802.3bv Link Monitor State Diagram Improvement to avoid glitch on rem_rcvr_status

- Link monitor state diagram in 802.3bv D2.0: problem statement
- Link monitor state diagram refinement proposal for 802.3bv D2.1

Link monitor state diagram in 802.3bv D2.0

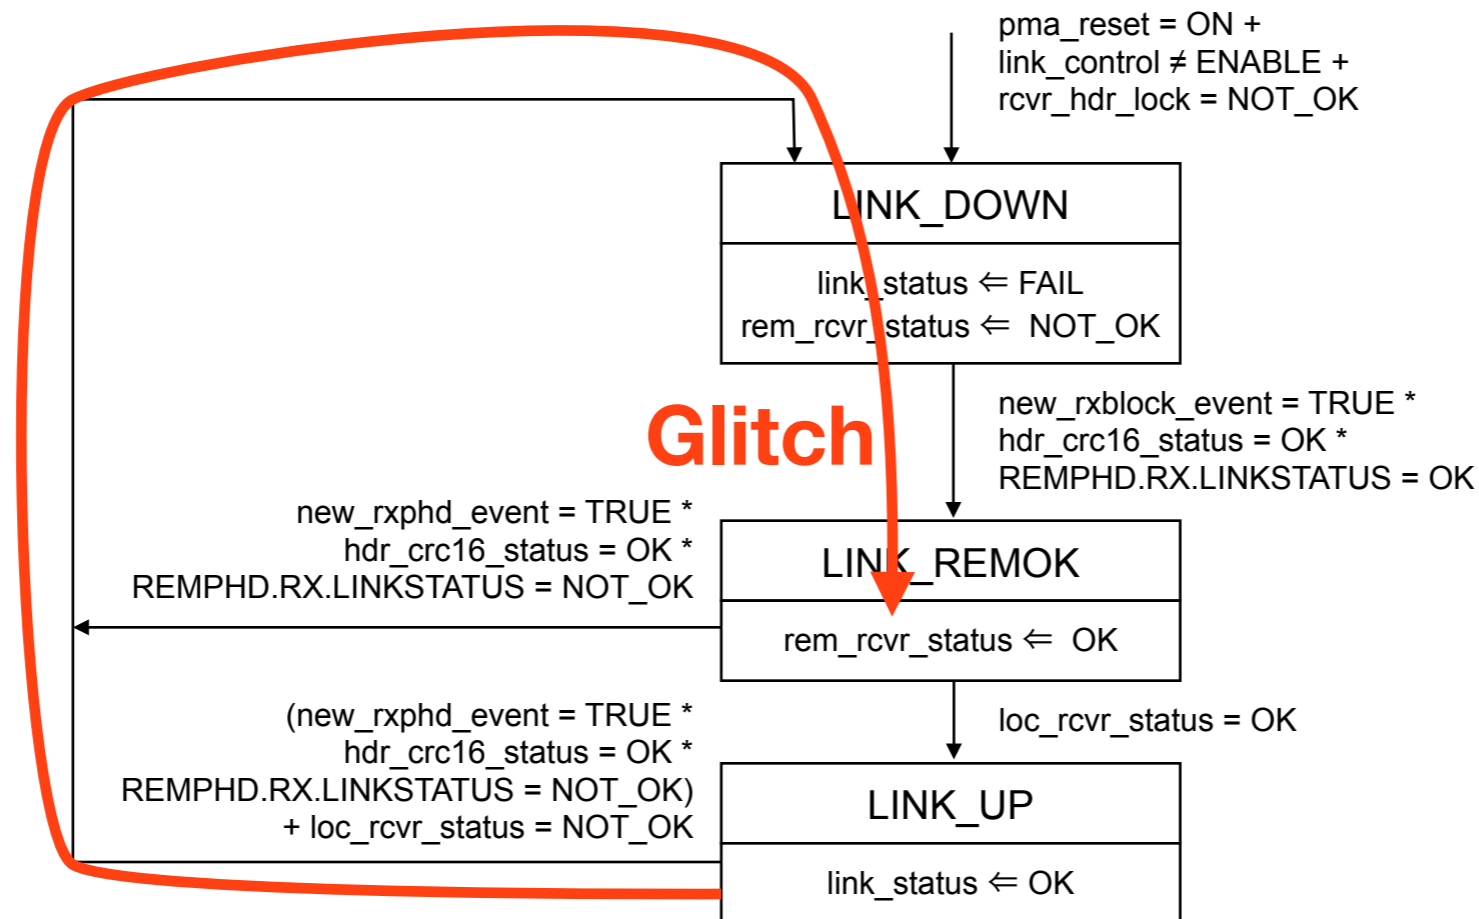
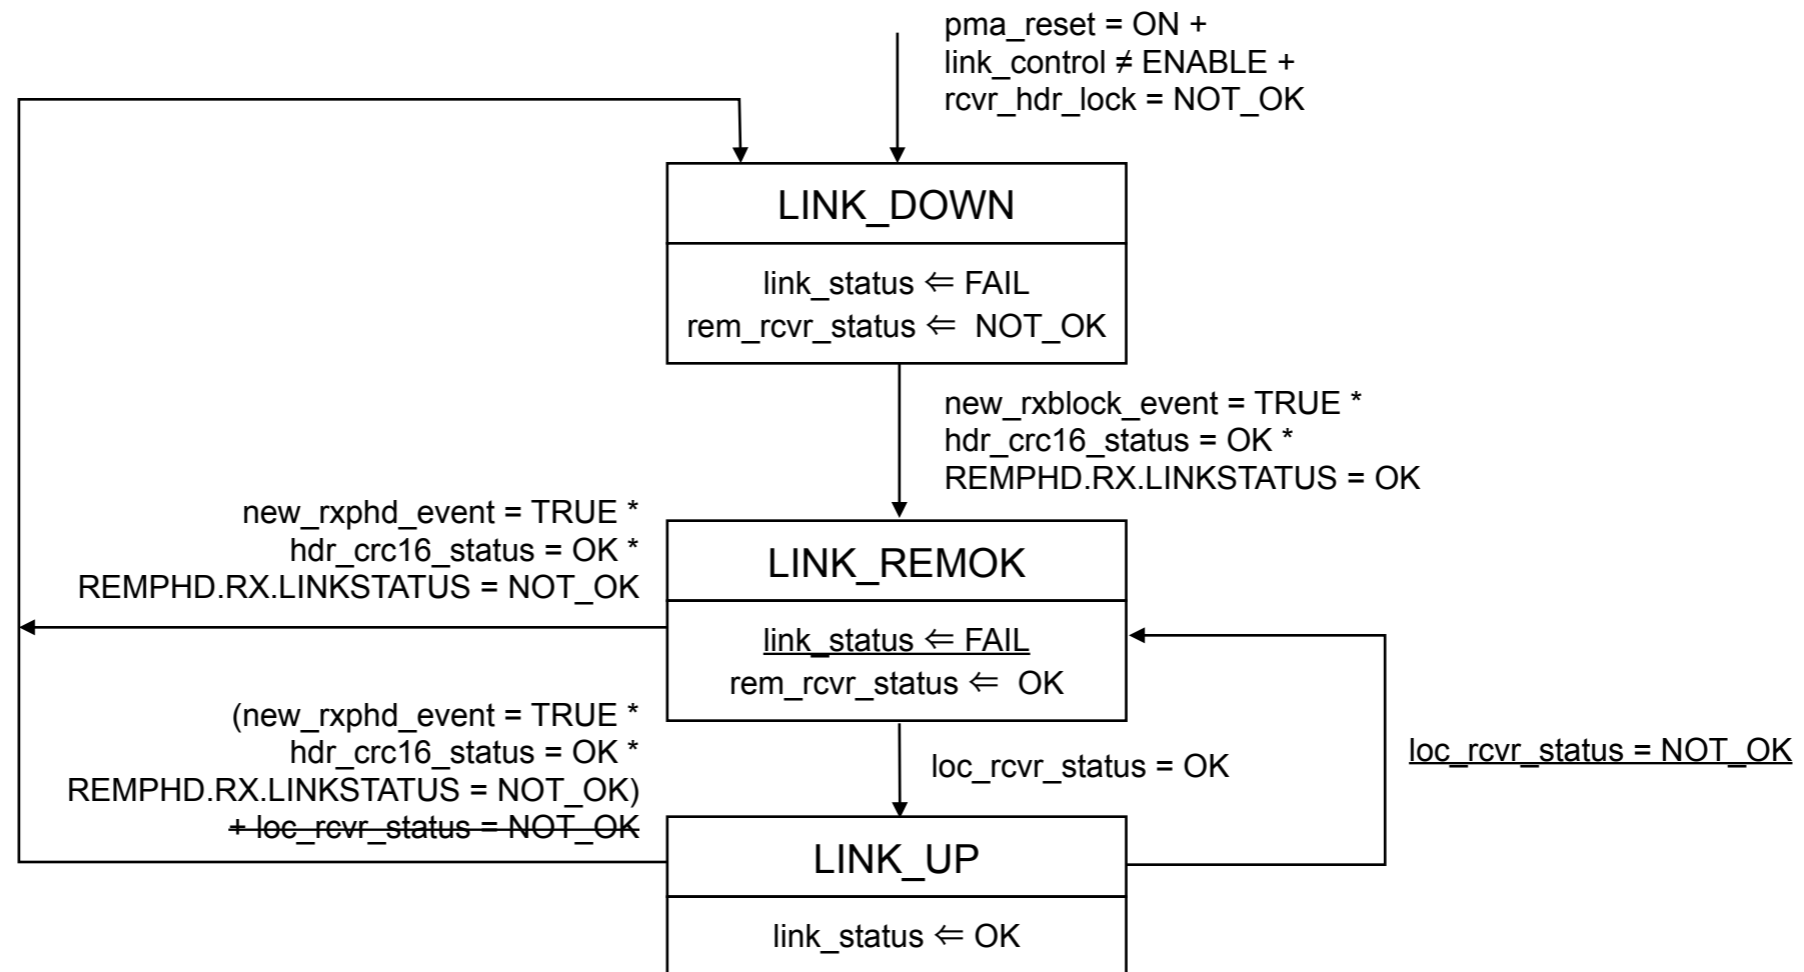
PMA Check Quality SD indicates `loc_rcvr_status ⇐ NOT_OK`, but remote PHY receiver stays indicating OK
